**JOPPATOWNE HIGH SCHOOL  
LIMITED RENOVATION  
JOPPATOWNE, MARYLAND**

**ADDENDUM NO. 5**

**May 18, 2020**

AD-5 SK-9 PART P0.32

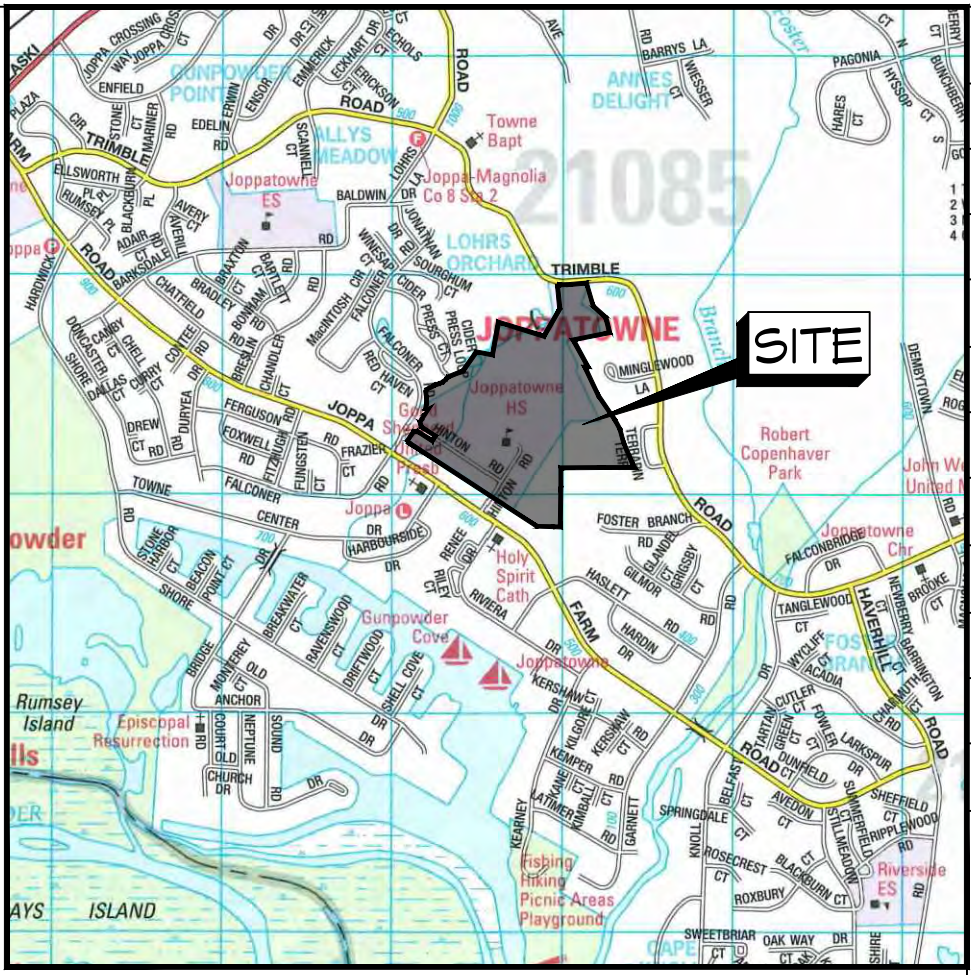
AD-5 SK-8 – PART P0.32: Revised pipe hanger support notes.

C-03

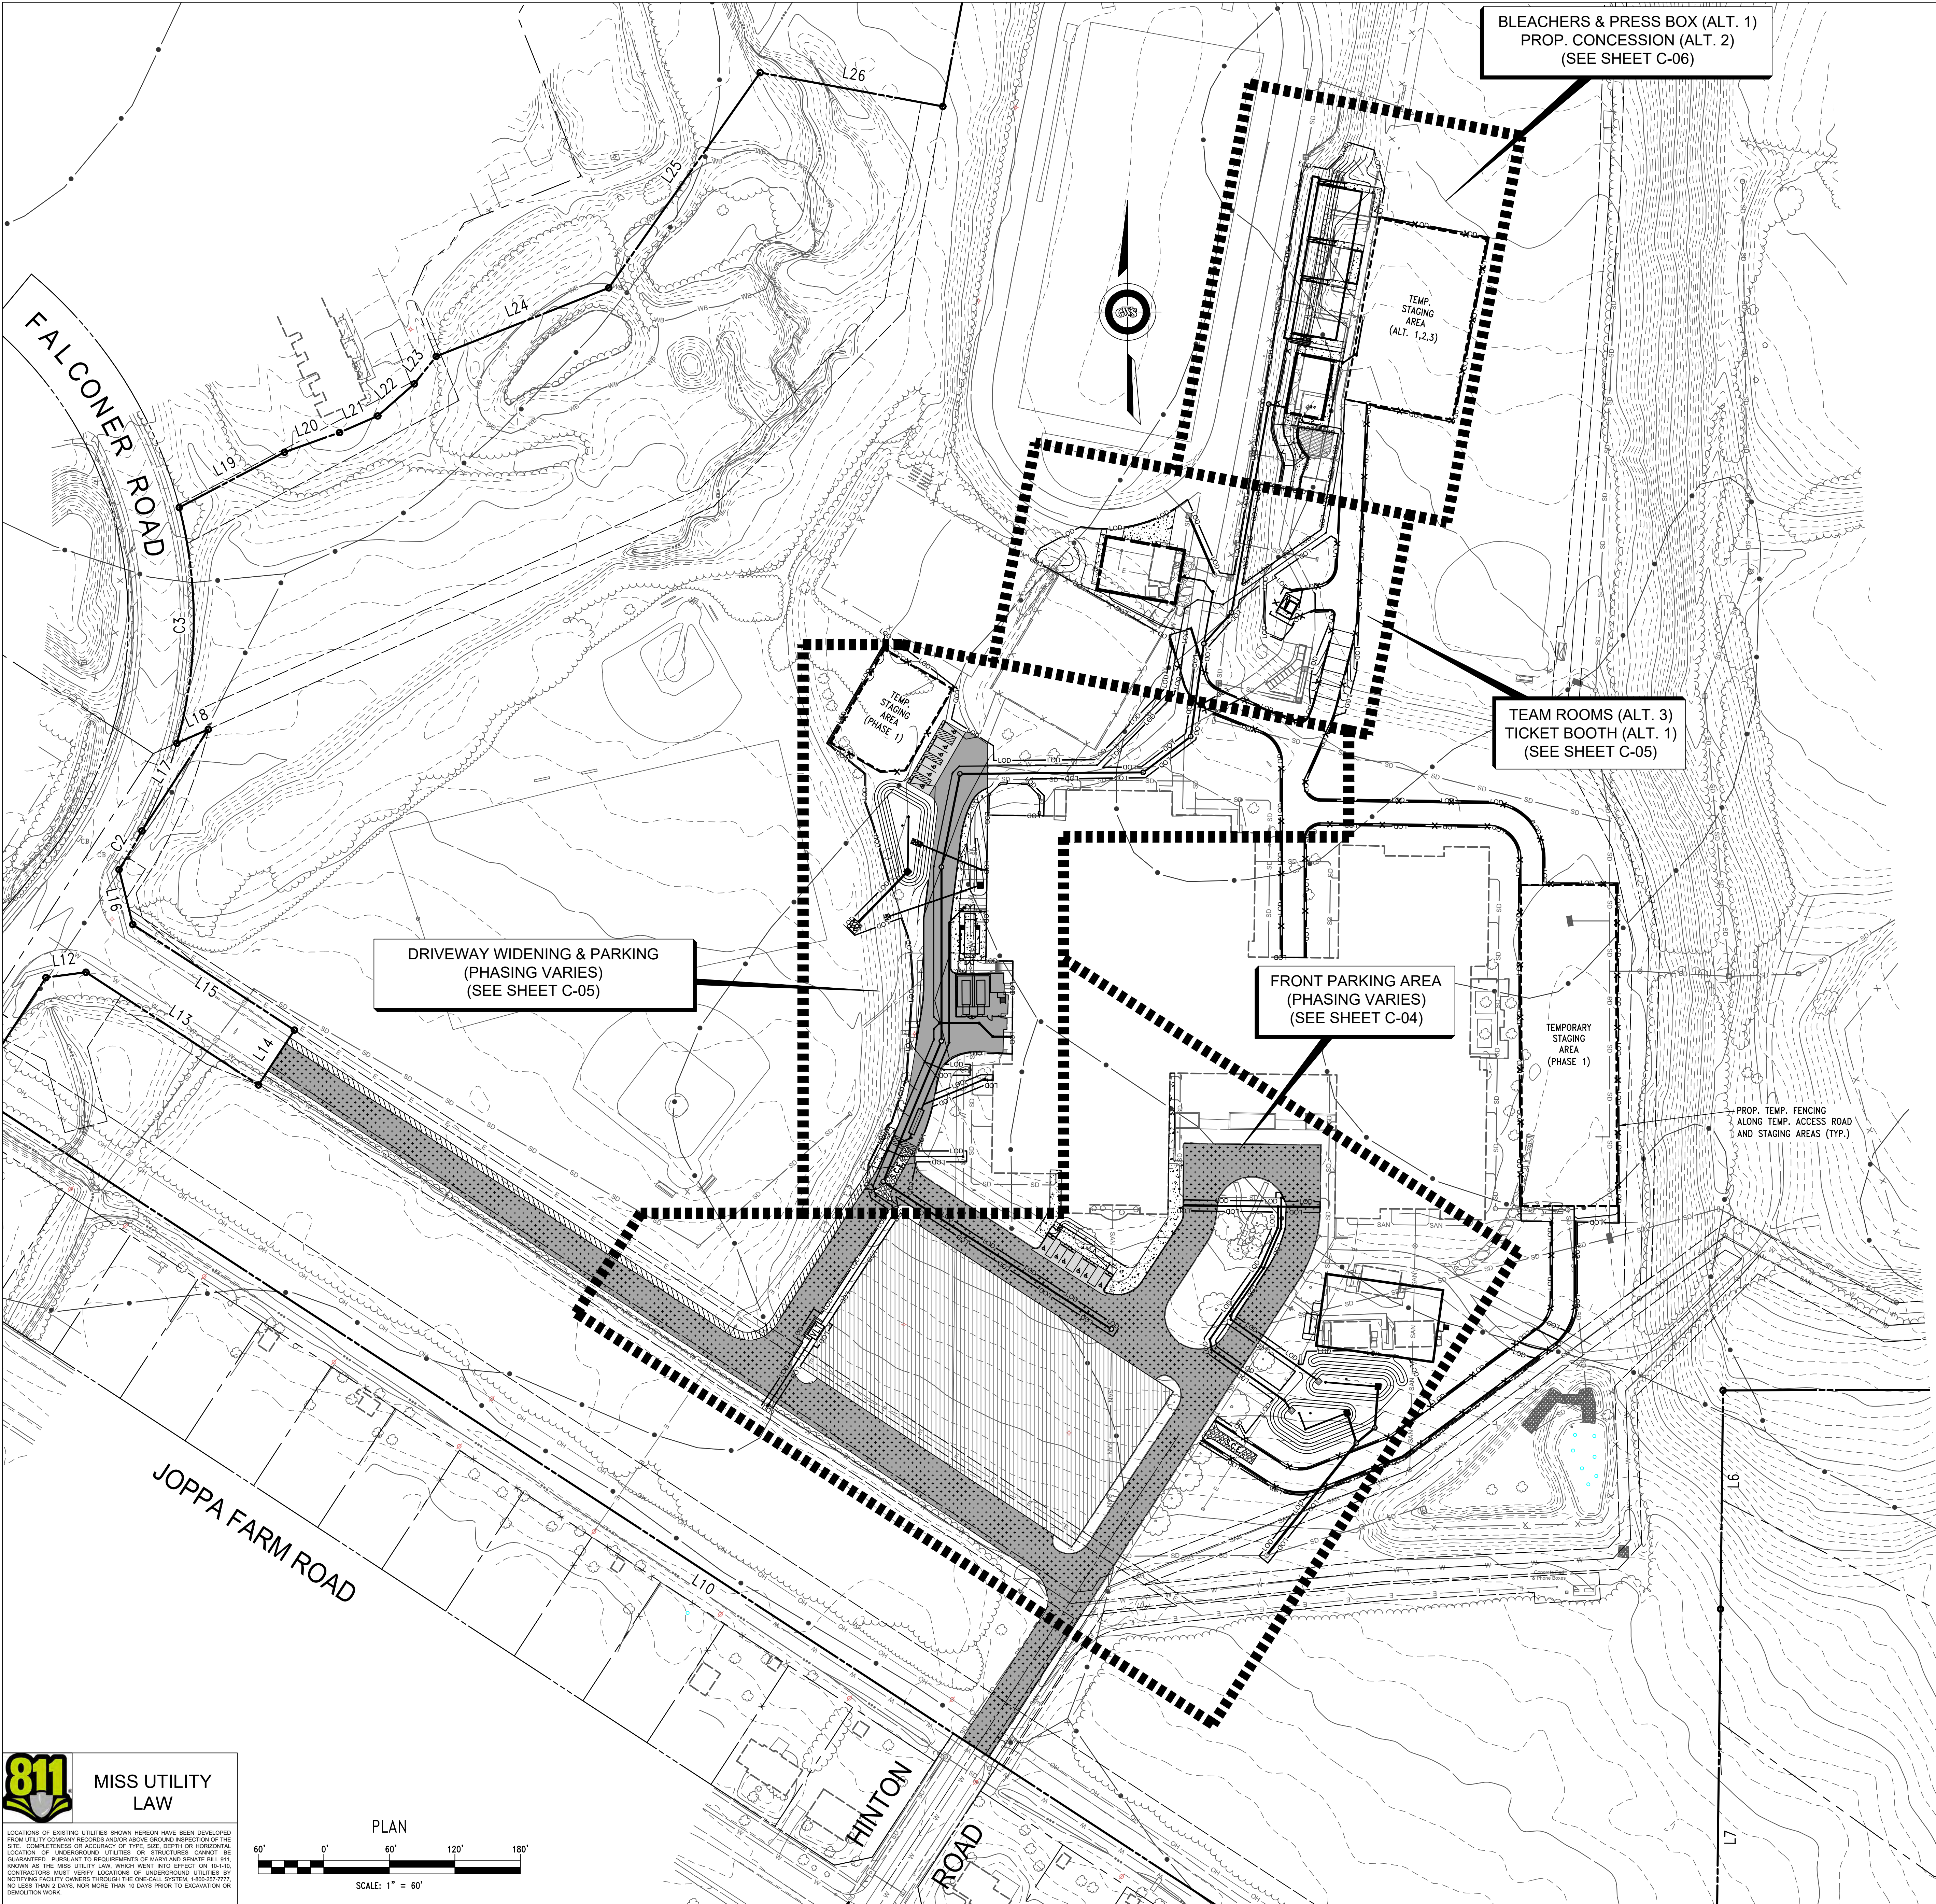
- A5.17 DRAWING C-03: See attached re-issued C-03 clarifying paving for drives and milling/repaving of existing parking lot.
- A5.18 DRAWING C-0.5: See attached supplemental sketch AD-5 SK-5 for running track repair where 15" RCP crosses existing end of running track.

C-03 SITE IMPROVEMENTS SITE PLAN:

Clarified paving of drives and milling/repaving of existing parking lot.
